RE: Administrative Review of Revised Landscaping Plans – AR 21 20 DR 03

**RESOLUTION:** **AR 21 20 DR 03 – Cannery Station Cottages Lots 3 & 4**

**STAFF REPORT & FINDINGS OF FACT  
 FLORENCE COMMUNITY DEVELOPMENT DEPARTMENT  
 Exhibit "A"**

**Date of Report:** August 16, 2022 **Planner:** Henry Hearley, LCOG  
**Application:** AR 21 20 DR 03  
**Related Files:** PC 21 20 SUB 01; PC 21 12 EAP 02; PC 18 12 PUD 01; PC 18 33 PUD 02; & PC 18 34 SUB 01

**LOTS 3 & 4 LANDSCAPE PLAN**

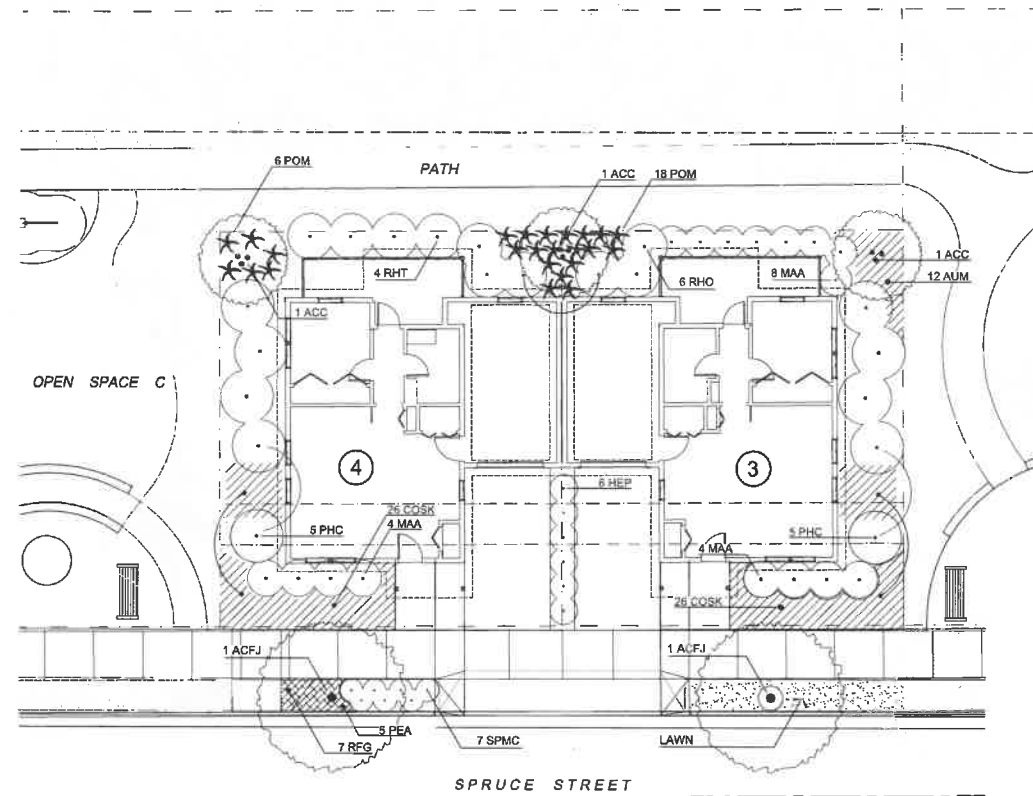
As seen on Sheet LA-1, the entire area between Spruce Street and the two transitional cottages are proposed to be landscaped. Criterion met.

As seen on Sheet LA-1, there are two Autumn Blaze Maple trees proposed on the planter strip in between the two transitional cottages and the street. The two Autumn Blaze Maple trees meet the required spacing of one tree per 30 lineal feet. Criterion met.

As seen on Sheet LA-1, the planter strip and the area immediately in front of the two transitional cottages is proposed to be heavily landscaped with grasses and groundcover, including ten Physorcapus capitatus shrubs, eight Mahonla aquifollum shrubs. Criterion met.

As seen on Sheet LA-1, the required plant materials on-site will be located in areas within the first 20 feet of any lot line that abuts a street. Criterion met.

As seen in the Plant Schedule on Sheet LA-1, a majority of the trees, shrubs and ground covers proposed to be used on the site, are included in the City's Tree and Plant List. Criterion met.

The site is proposed to contain 36 percent landscaping. Living plant materials shall cover a minimum of 70 percent of the required landscape area within 5 years of planting. [Condition 3]

The applicant shall provide pocket-planting with a soil-compost blend around plants and trees to ensure healthy growth per FCC 10-34-3-3 A 5. [Condition 4]

The applicant shall follow the planting standards for ground cover, shrubs, trees and non-plant ground cover, as listed in FCC 10-34-3-4(A)(1-4). [Condition 5]
